# Access Compliance Report

## Public Rights-of-Way

Intersection ID: 10796	Main Street: LEIGH_AV	Cross Street: PINCKNEY_AV	Location: S
ADA ID: CCBA326FDF17	Ramp Type: Perp	Initial Pass/Fail: Fail	Overall Compliance: No
Severity Score: 10			
Codes/Mitigation Info/Possible Solution		Field Measurements/Component Compliance

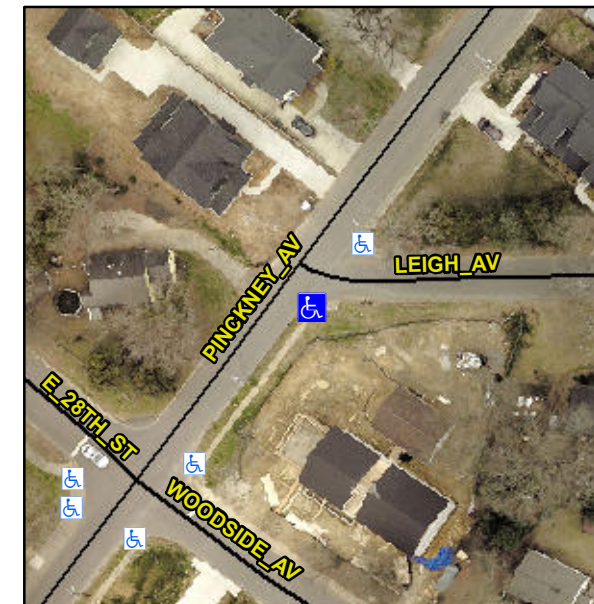
**Remove & Replace Entire Ramp.**

**R304.5.1, R304.5.3**

Compliance	Description	Data	Compliance	Description	Data
N/A	Ramp Length (in)	65.0	Yes	Ramp Slope (%)	6.8
No	Ramp Width (in)	38.5	No	Ramp XSlope (%)	4.8
N/A	Flare Type LT	N/A	N/A	Flare Type RT	N/A
N/A	Flare Slope LT (%)	N/A	N/A	Flare Slope RT (%)	N/A
N/A	Flare Traversable LT?	N/A	N/A	Flare Traversable RT?	N/A
N/A	Landing Length (in)	N/A	N/A	DWS Provided?	N/A
N/A	Landing Width (in)	N/A	N/A	DWS Contrast?	N/A
N/A	Landing Slope (%)	N/A	N/A	DWS Length (in)	N/A
N/A	Landing X Slope (%)	N/A	N/A	DWS Full Width?	N/A
N/A	Landing Curb? (Y/N)	N/A	N/A	DWS Offset (in)	N/A
N/A	Shared Landing?	N/A			
N/A	Gutter Ponding?	N/A	N/A	Gutter Slope (%)	N/A
N/A	Gutter Lip Ht (in)	N/A	N/A	Gutter X Slope (%)	N/A
N/A	Painted X Walk1?	No	N/A	Painted X Walk2?	N/A
	X Walk 1 Direction	To NE		X Walk 2 Direction	N/A
N/A	X Walk 1 Width (in)	N/A	N/A	X Walk 2 Width (in)	N/A
	X Walk 1 Slope (%)	4.6		X Walk 2 Slope (%)	N/A
	X Walk 1 X Slope (%)	3.0		X Walk 2 X Slope (%)	N/A
